To:
Plan Holders
MMA Outdoor Fire Pit

RE: Addendum 1

GRANITE SEATING, TYPICAL - PLAN VIEW

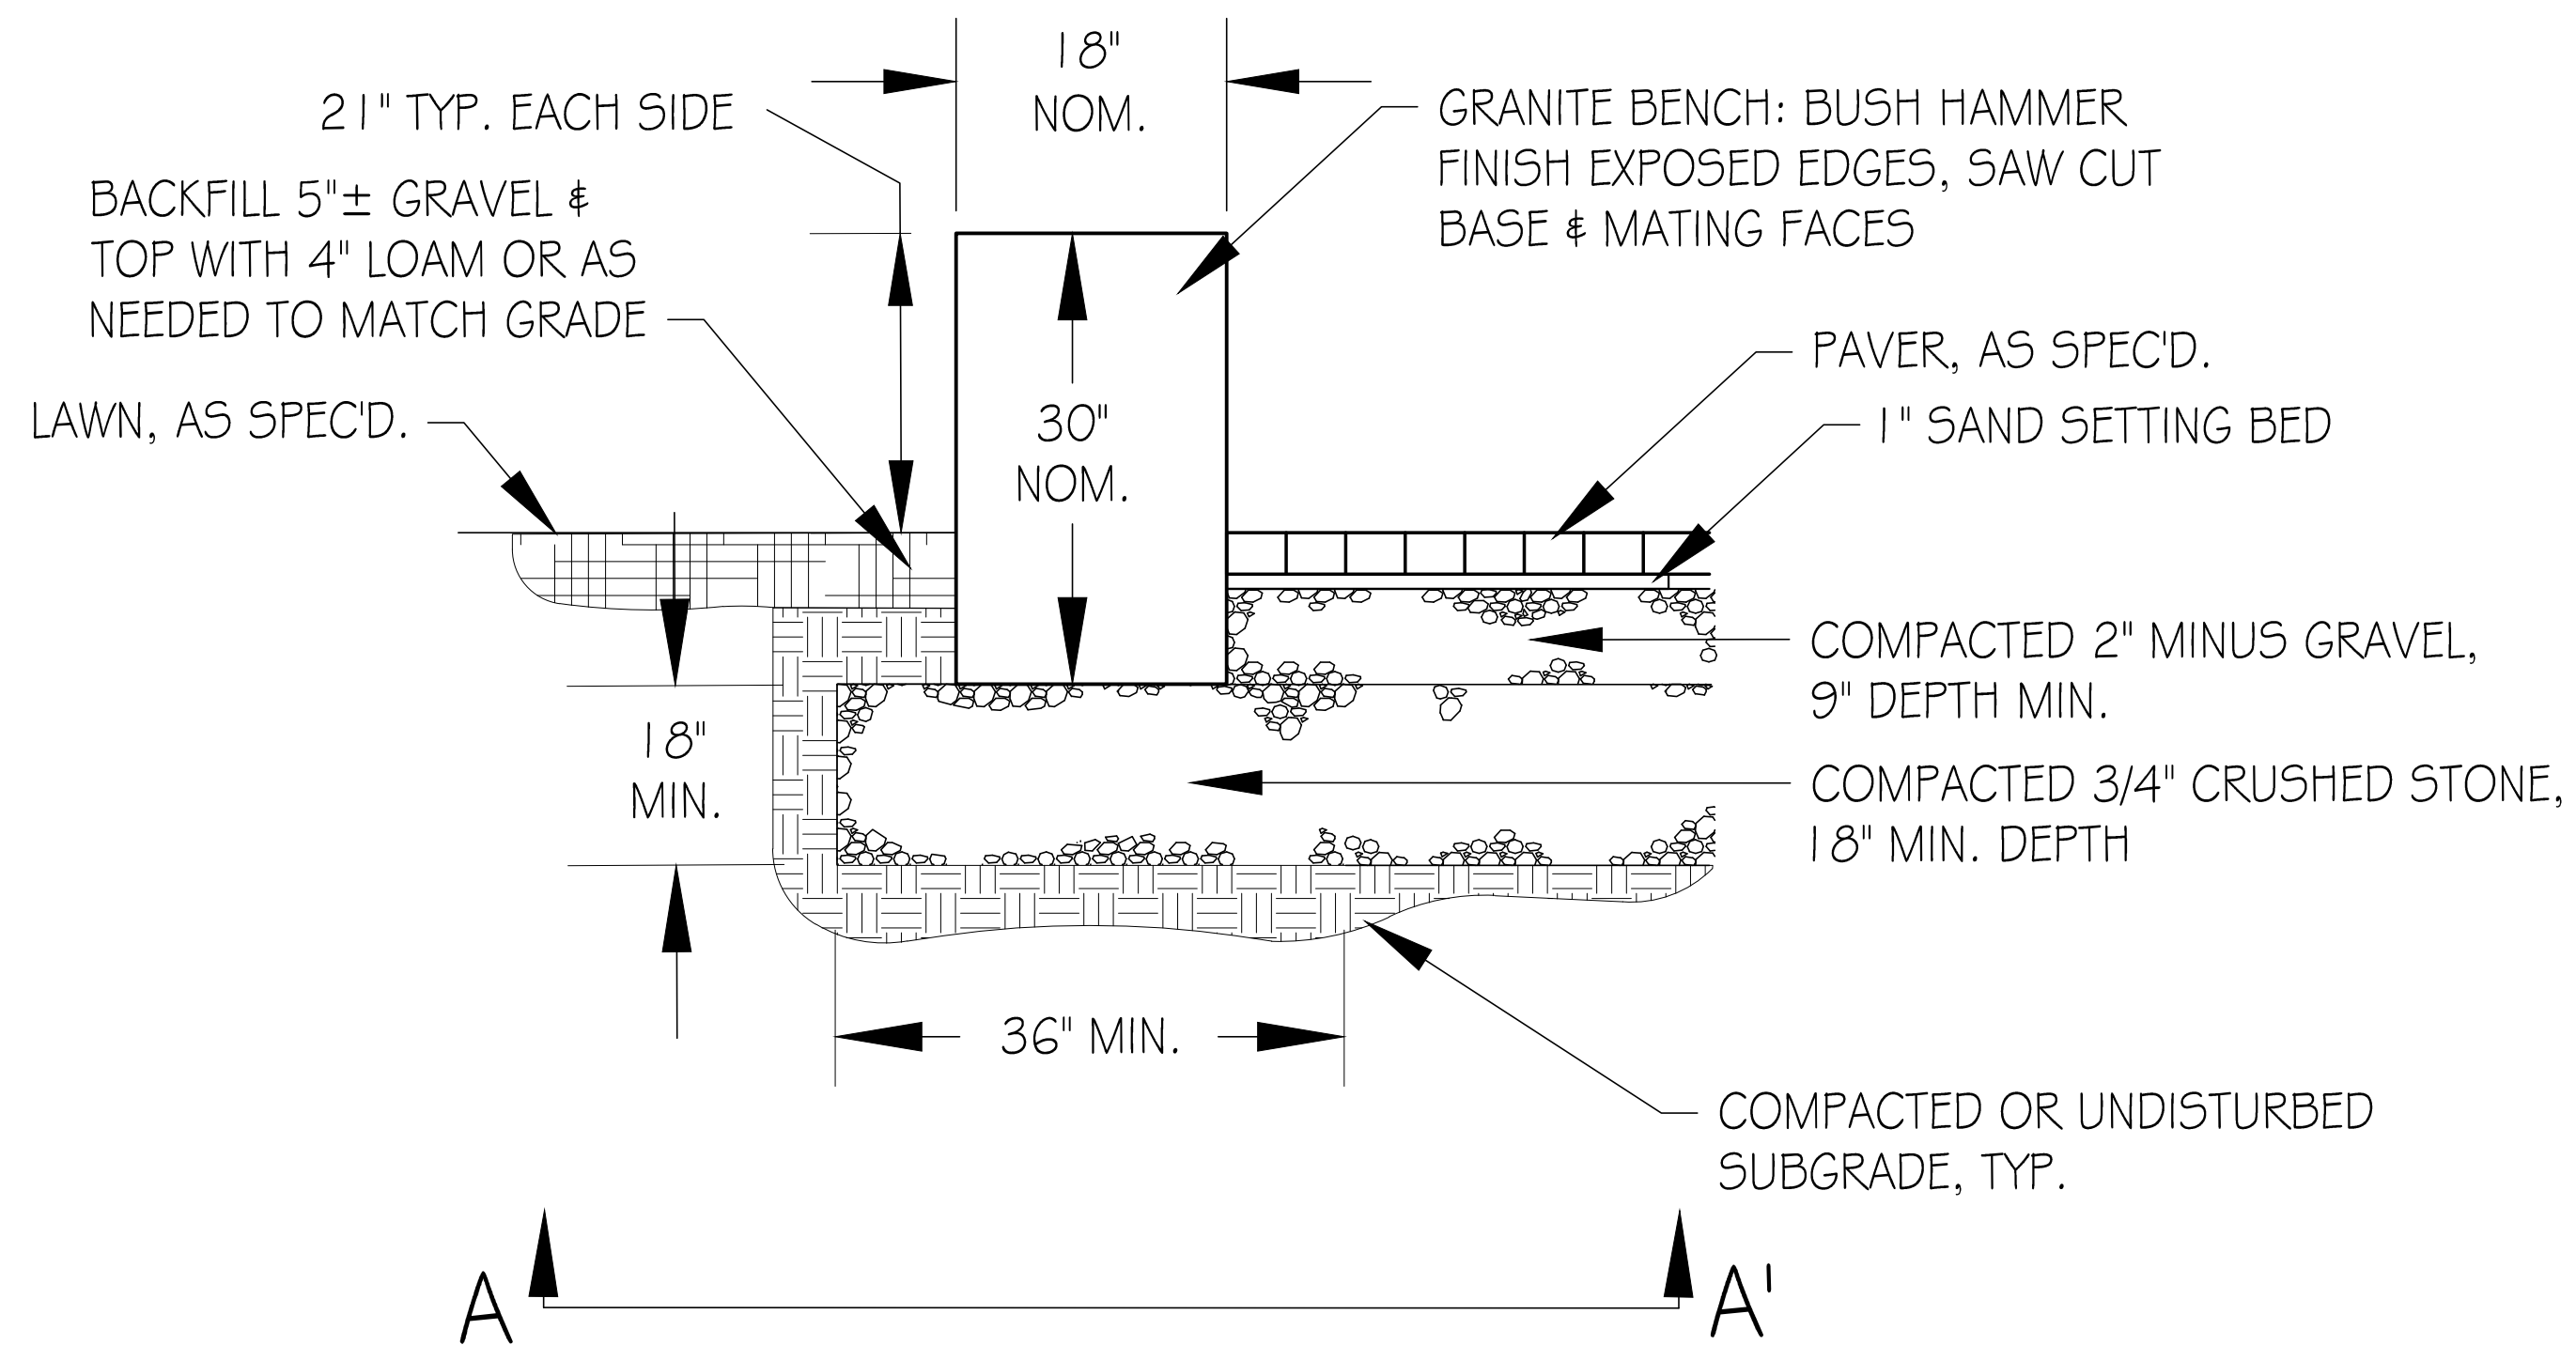
1. See attached wage determination.
2. Key on single line diagram, detail 5/L3.1: The project does not include a manual gas shut off key valve, wall switch or timer.
3. Provide a non-woven geotextile underneath pavers.
4. Fire bowl: Provide the 42-inch wide model.
5. Detail 3/L3.1: The fire pit base is concrete, not granite.
6. See attached scale drawing of the seating.
7. The completion date is May 1, 2019.
